RE: Whitewood Creek Restoration, Deadwood SD
Sites 1C, 2A, 2B, 3A, & 3B
Cost Proposal #05 – Proposal Request No. 5 (January 23, 2024)

REQUEST FOR PROPOSAL

Whitewood Creek Restoration – BP #1

PROPOSAL REQUEST NO: 5

SHEET IDENTIFICATION:
L-304

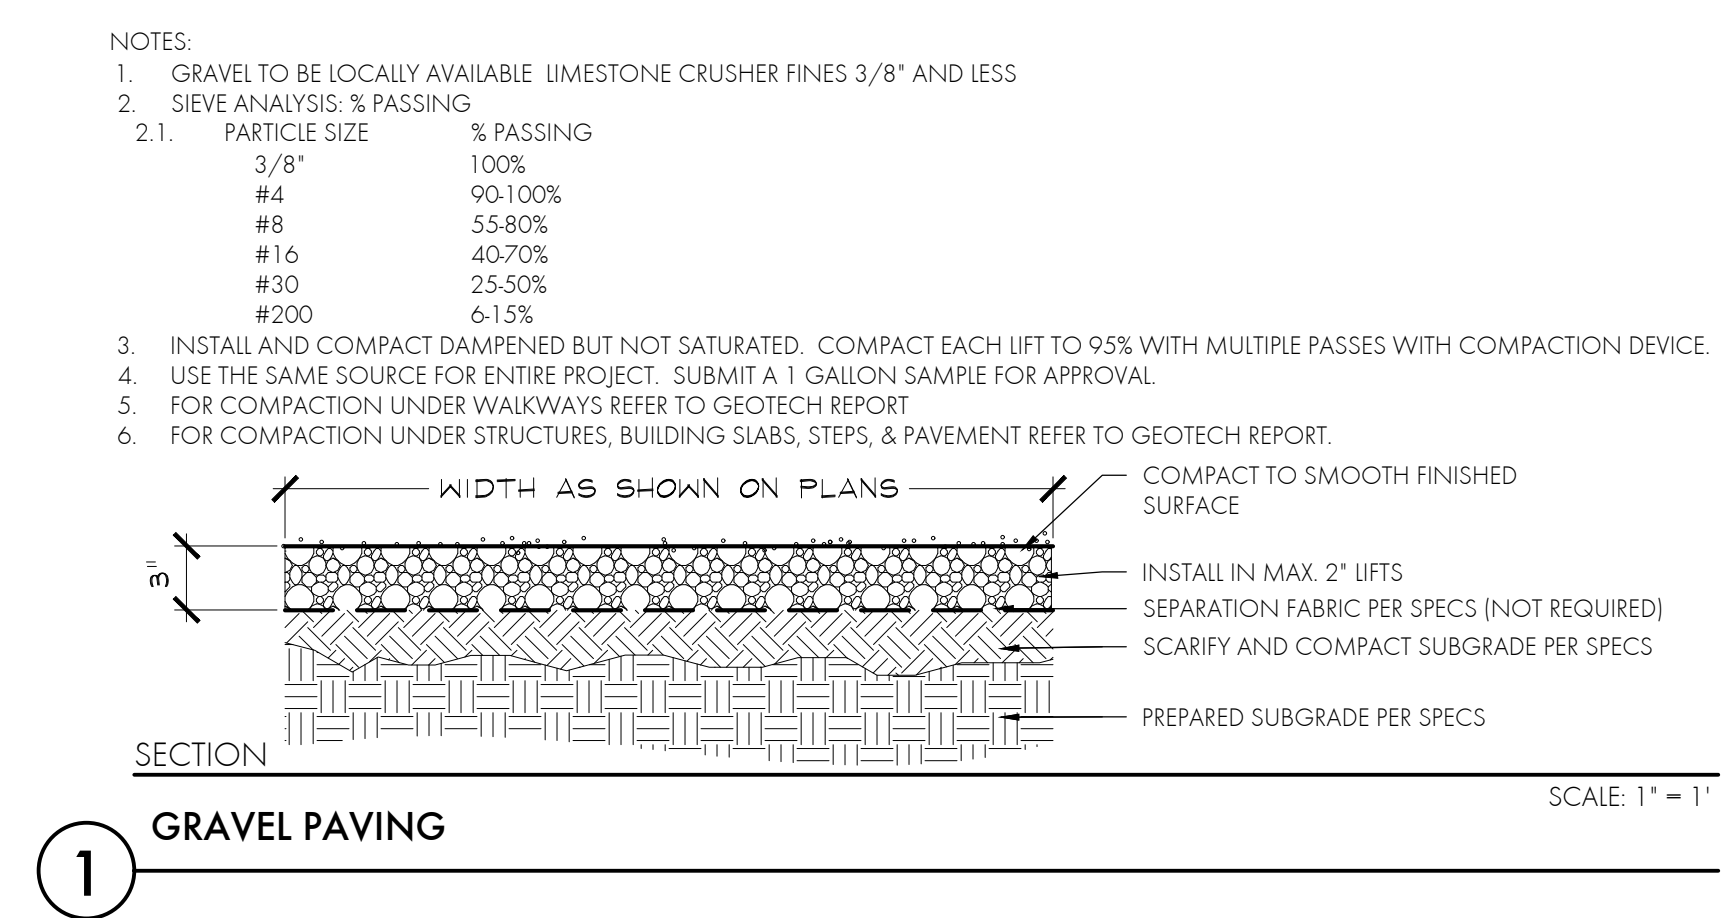
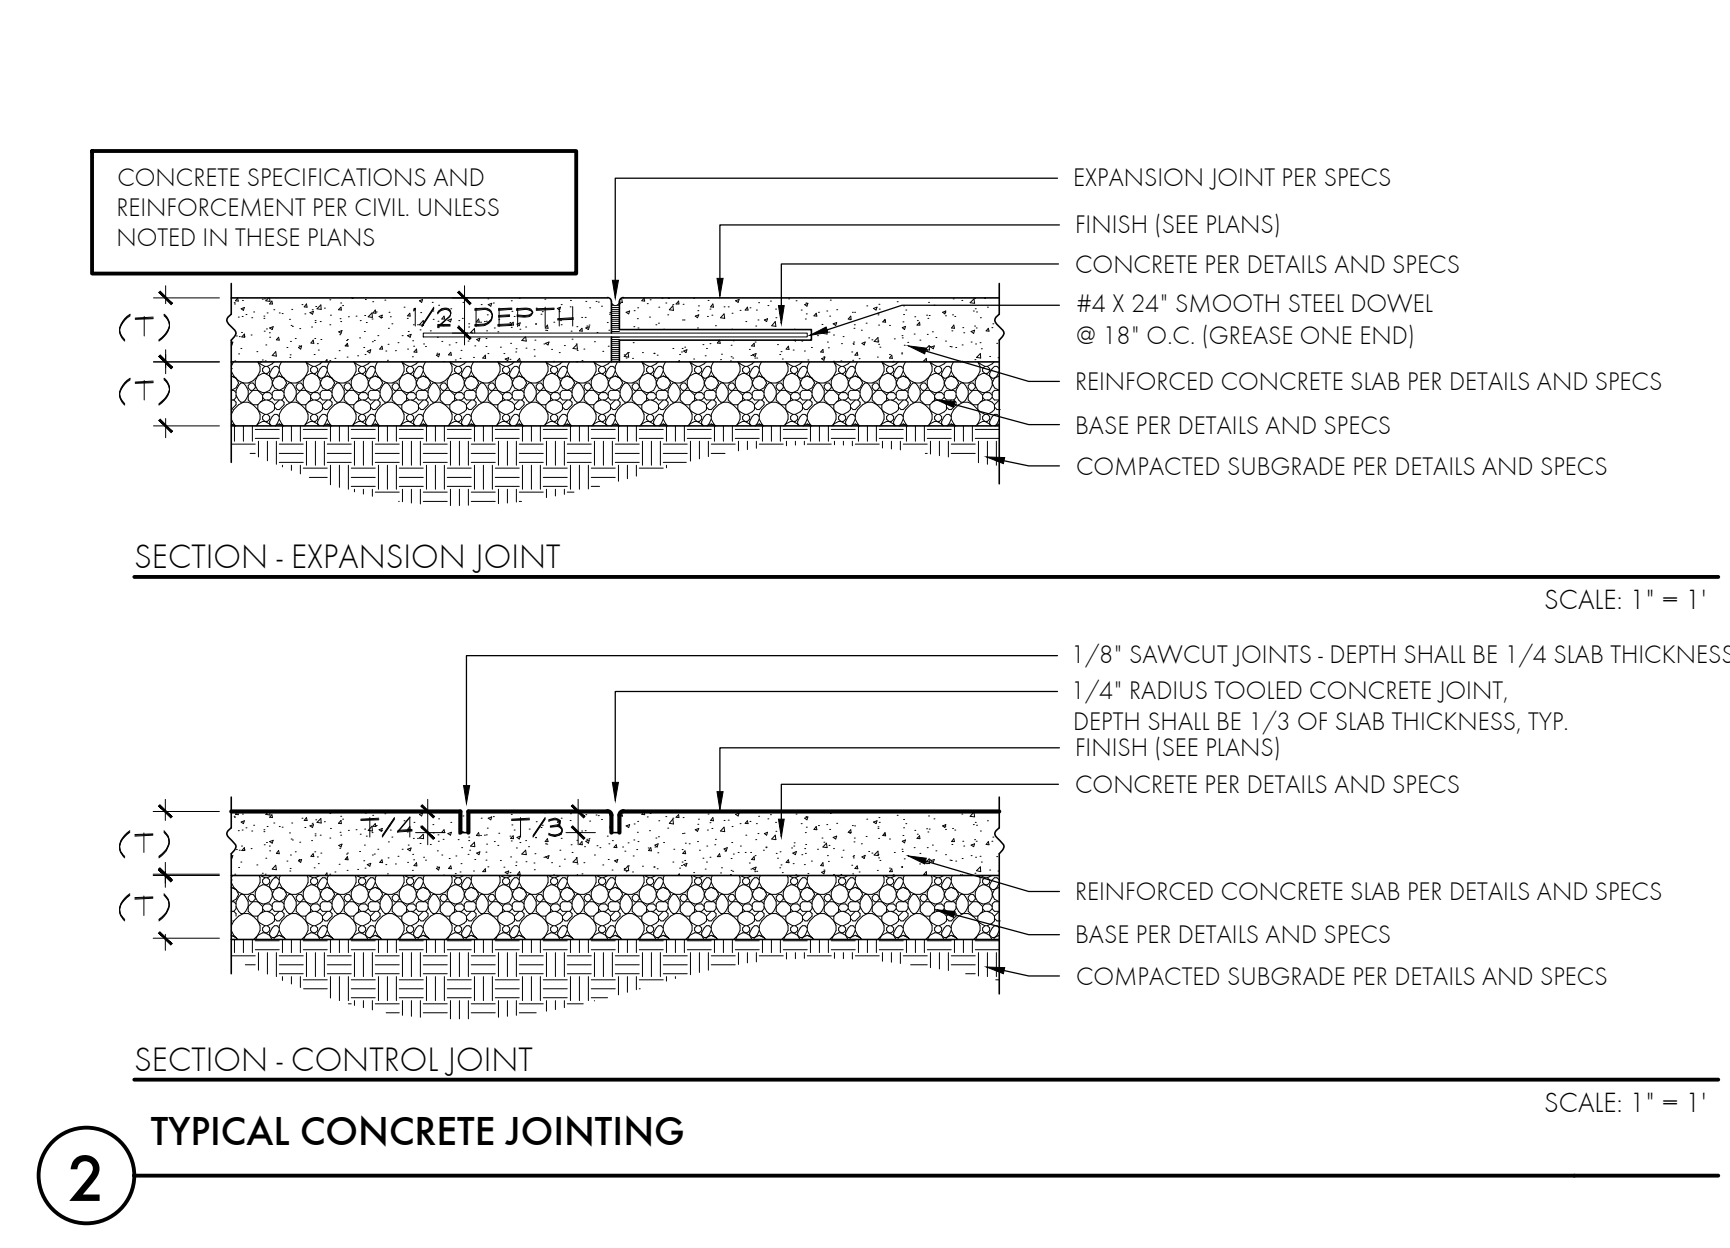
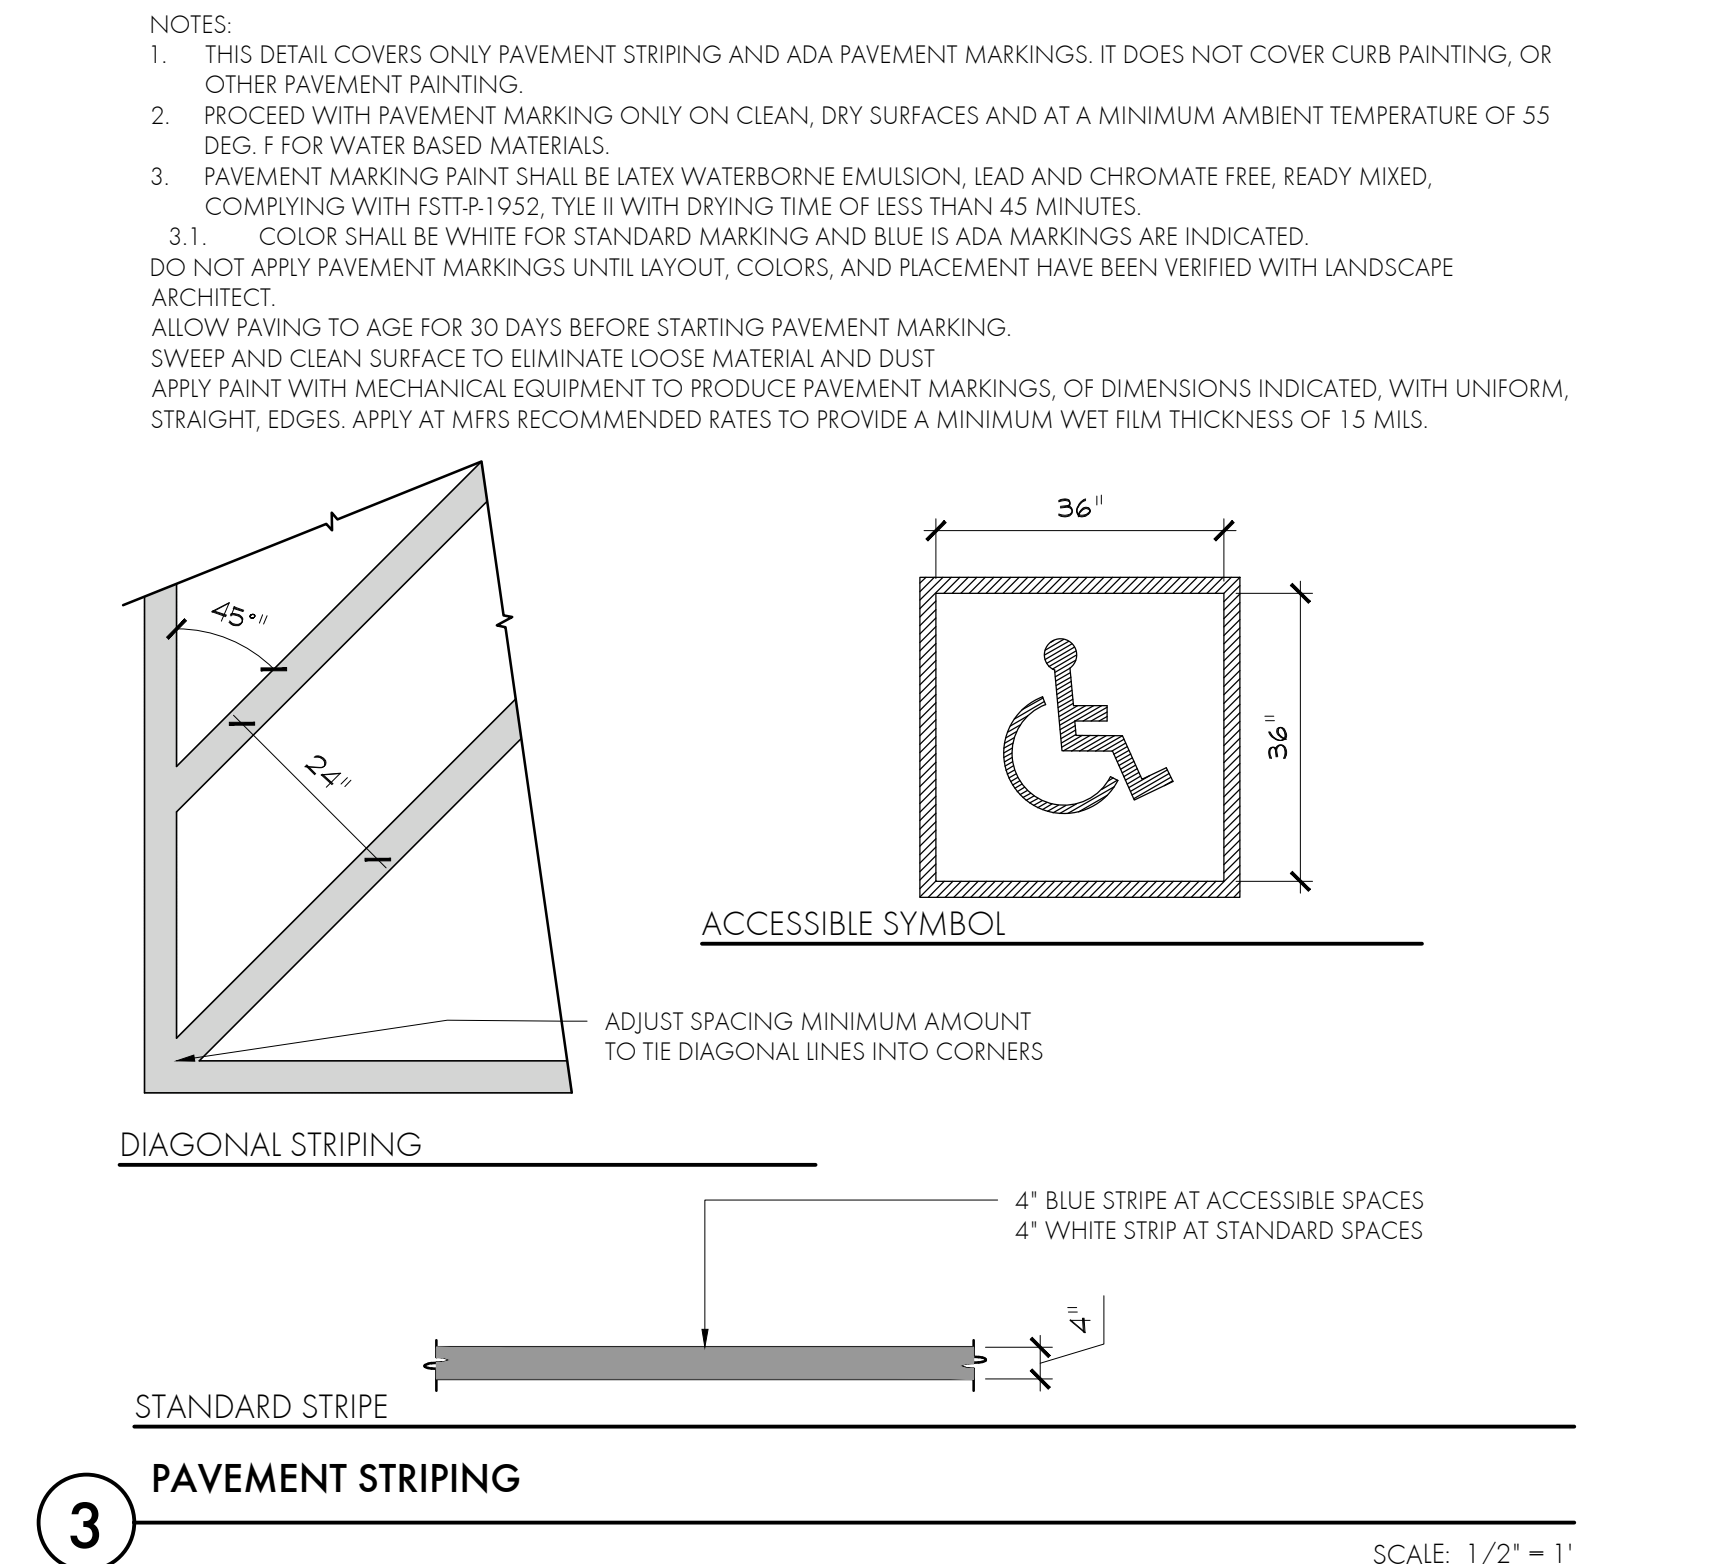
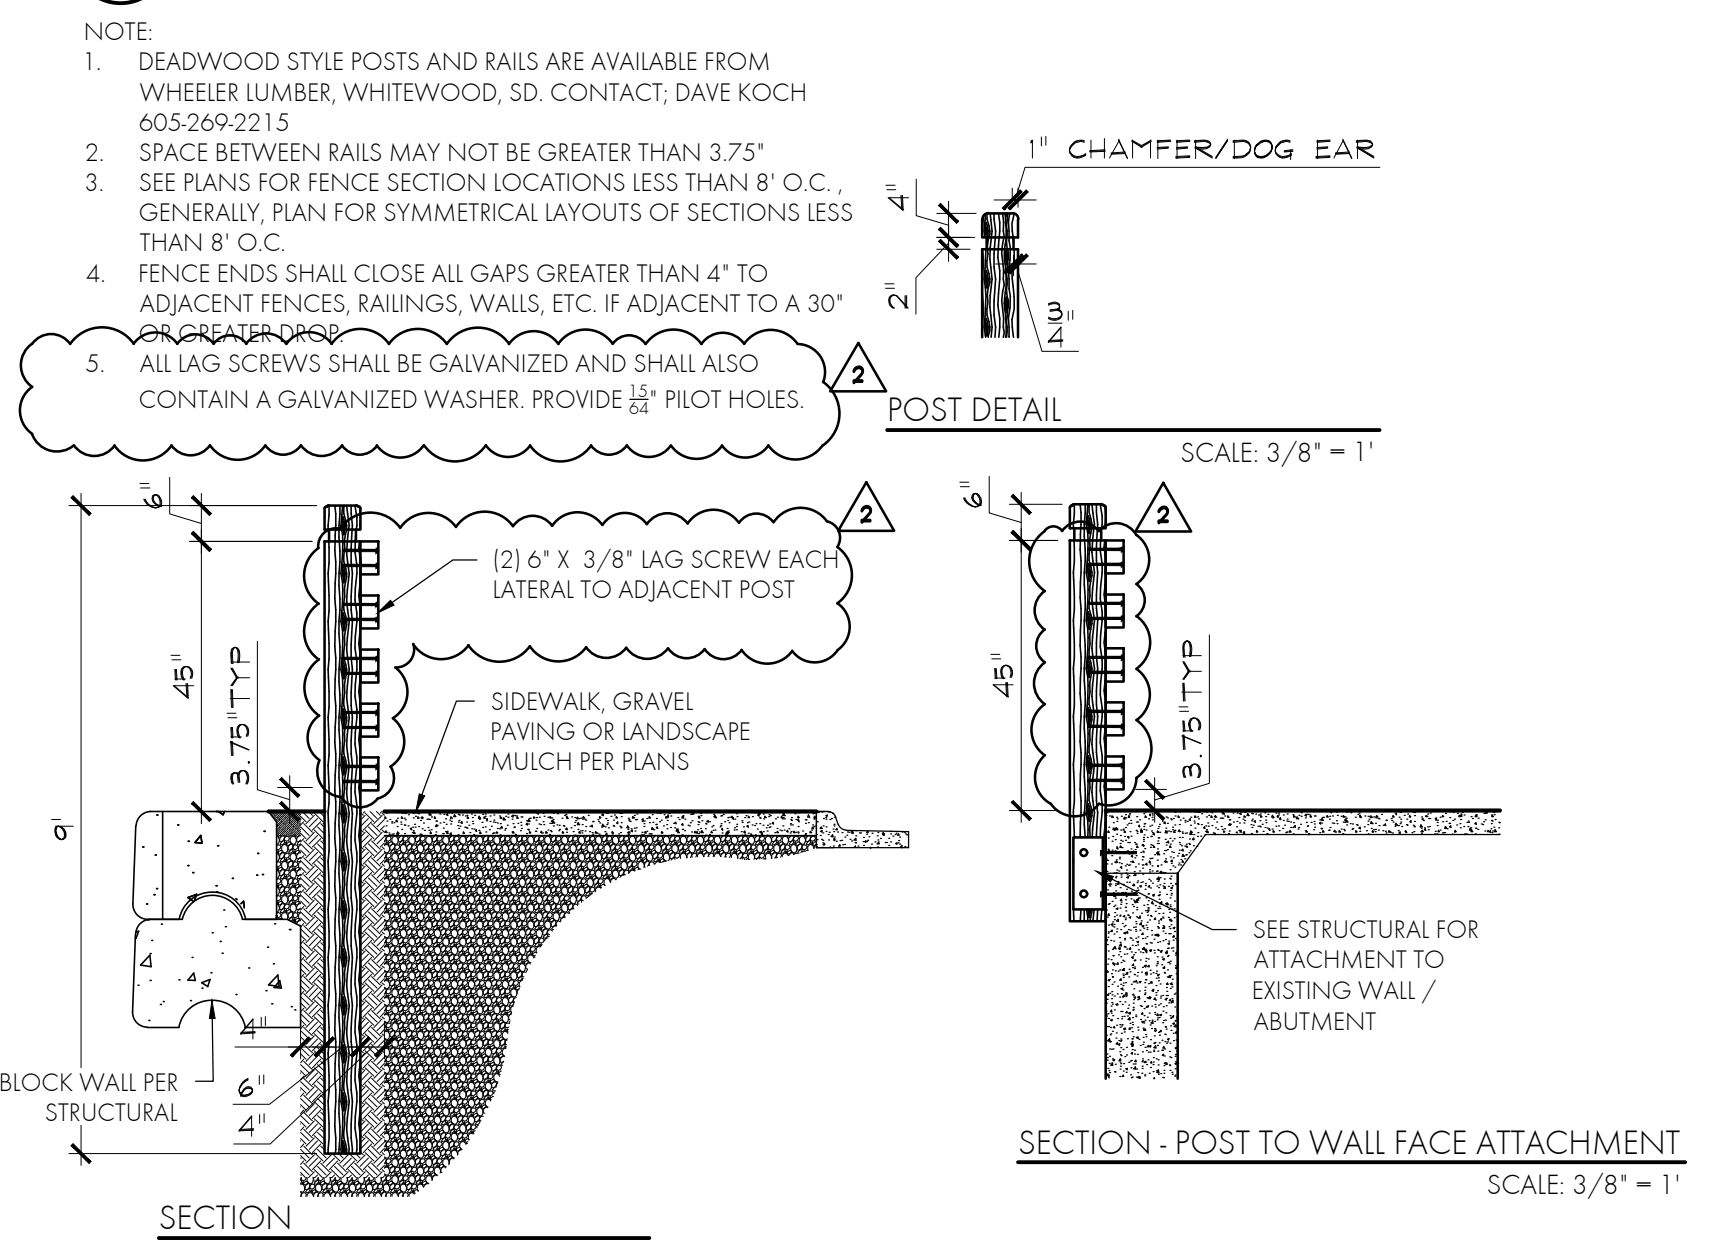
Supplemental Instruction to clarify that two (2) lag screws are required per fence rail to attach to post, consistent with the Section/Elevation in detail 4 sheet L-304. Also, stagger rail joints each row such that a fence post either has (14) or (16) total fasteners.
